What is the difference between Z794 & Z794A Oil Filters?

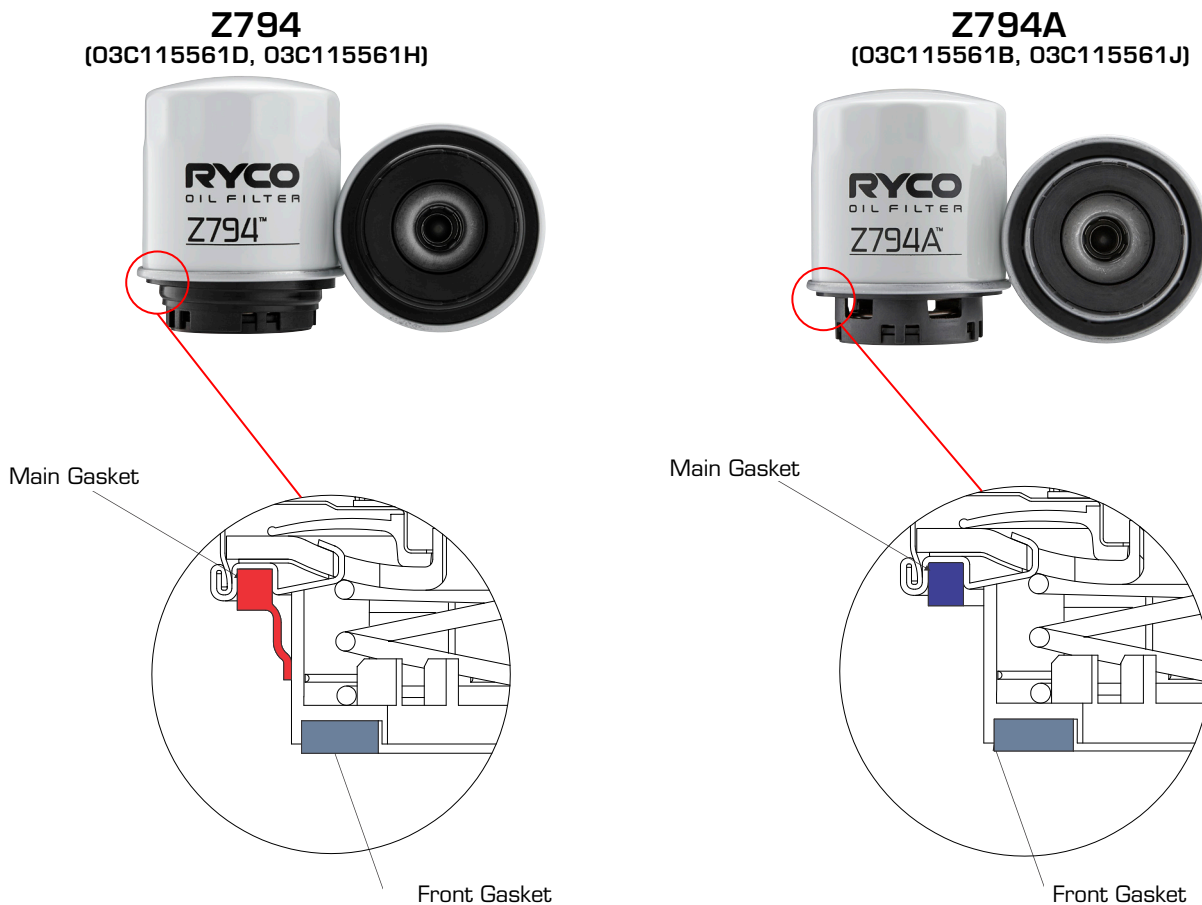
The difference between the two filters is in the main gasket/seal design:

Z794 design (OE X-Ref:03C115561D and 03C115561H) with “shoulder” on the gasket

Z794A design (OE X-Ref:03C115561B and 03C115561J) with “square/flat” gasket design

FITMENT TIP: Having the correct gasket configuration for the correct application is critical. It must be reinforced that the correct torquing of both filters to the OE recommended **20-22 Nm** is required to ensure sealing and prevent leakage.
